IIoT Product End-of-Life Notice

End of Life, Last Time Buy and Replacement Announcement

For immediately release, Advantech is announcing the End of Life (EOL) of **FPM-Dxxx (AE version)**, **TPC-5000 series (AE version)**, **TPC-2000 series (AE version)** and **FPM-7002 series (AE version)**. The relative replacing models are as below list. Customers who had purchased this Part Number either to purchase any additional rules or migrate to the new replacement models if possible before the EOL's shipment date.

4.1 Easy Installation

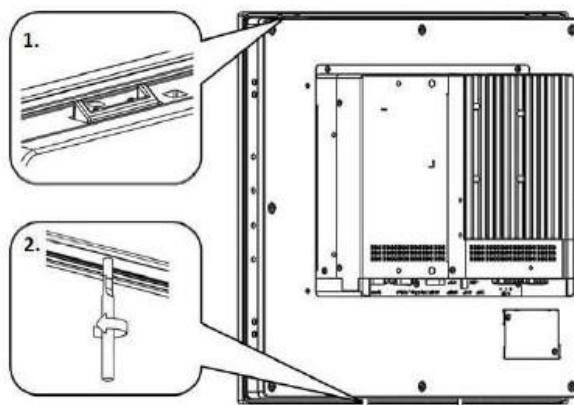
3) Remove 'Easy Installation' Feature

With the easy installation design, a single person can complete the panel mount process. Simply follow the steps outlined below.

4) New 'LCD Panel' (for 12", 15", 21.5")

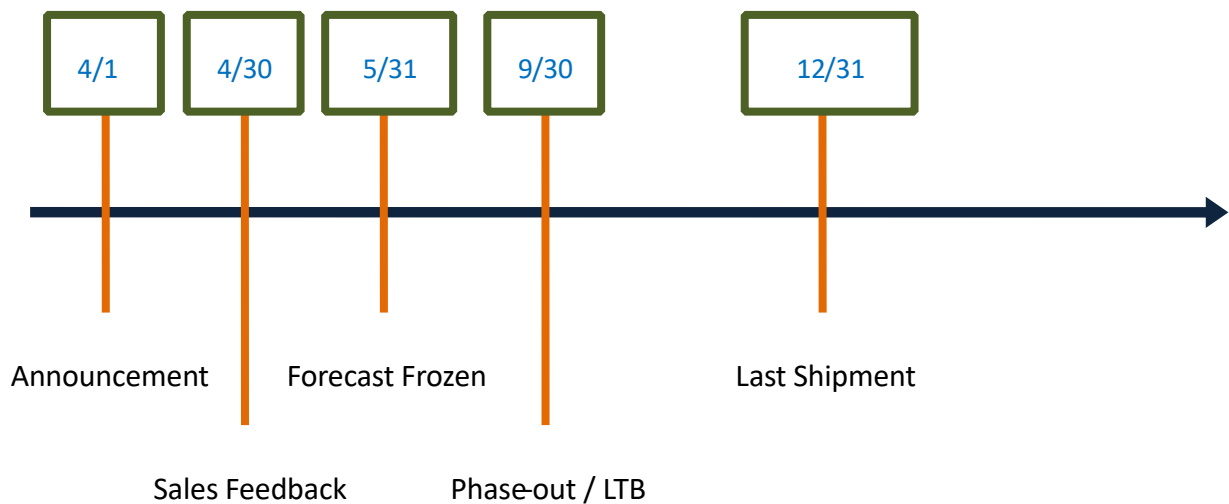
*Due to the EOL of the current 12" and 15" LCD panels, and the long period of usage of the current 21.5" LCD panel approaching EOL, the new Panels are introduced in the new BE versions for new

certifications, including CB/UL 62368.

12"			15"	
	Current	New	Current	New
LCD Panel (P/N)	96LEDK-C121XG50NB 1	96LEDK-C121XG60NB 1	96LEDK-C150XG40NG 9	96LEDK-C150XG30NG 1
Luminance (nit)	600	600	400	300
Viewing Angle (degree)	160/140	178/178	160/140	176/176
Contrast Ratio	700:1	1000:1	700:1	2000:1
Backlight Life (hr)	50,000	50,000	50,000	70,000

21.5"		
	Current	New
LCD Panel (P/N)	96LEDK-A215FH30NF2	96LEDK-A215FH25NF6
Luminance (nit)	300	250
Viewing Angle (degree)	178/178	178/178
Contrast Ratio	5000:1	1000:1
Backlight Life (hr)	50,000	50,000
